**ROAD LAYOUT
HOUSING DEVELOPMENT
FROGSTON ROAD (SPINE ROAD 1)
EDINBURGH**

STAGE 3 ROAD SAFETY AUDIT
(SPA Ref No: 4282)

Roads Authority: The City of Edinburgh Council

Client: Barratt Homes

Annex 2 PROBLEM LOCATION PLAN

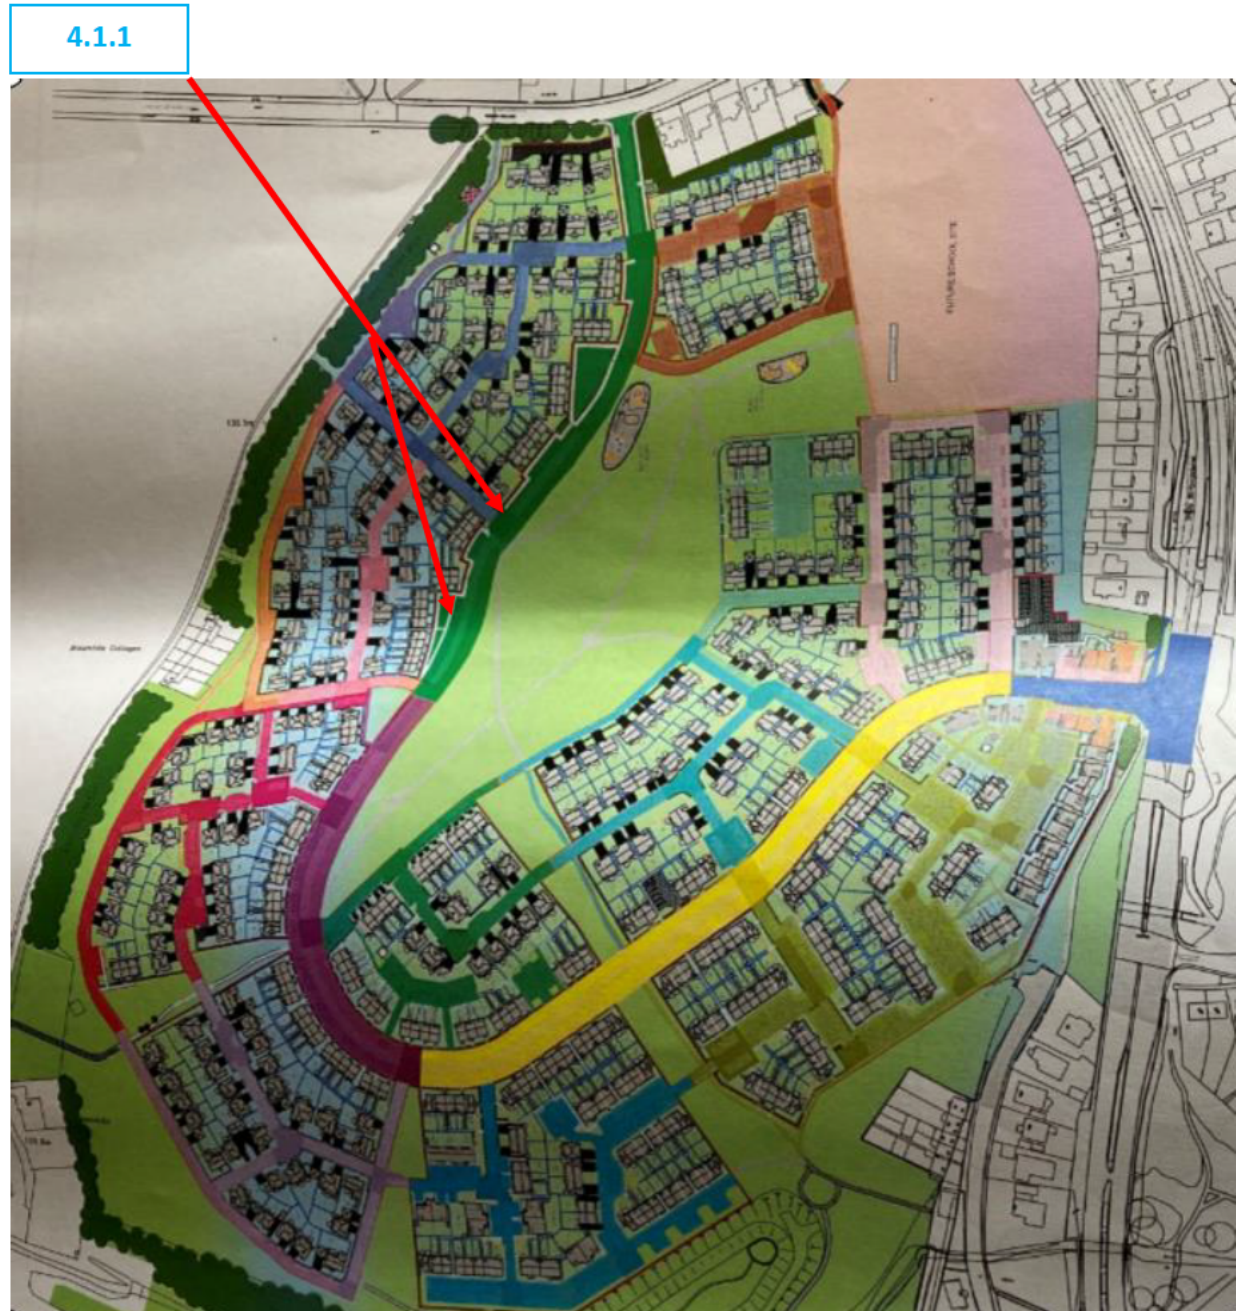
Location: Greenwell Wynd
Drawing(s): E9876~0925
Summary: Ponding on the carriageway can introduce skid / slip hazards to users.

On Greenwell Wynd there were two areas where significant ponding was noted. While it accepted this is not a shared space area and thus pedestrians may be affected in a limited

manner, the ponding could be an issue for cyclists in the winter months if ponding freezes over due to low temperatures..

The locations were opposite No 56 (where there is also a gully set low in the carriageway) and at the junction of Ellis Street.

It is recommended that the areas where ponding is occurring are rectified to ensure the carriageway drains as intended.
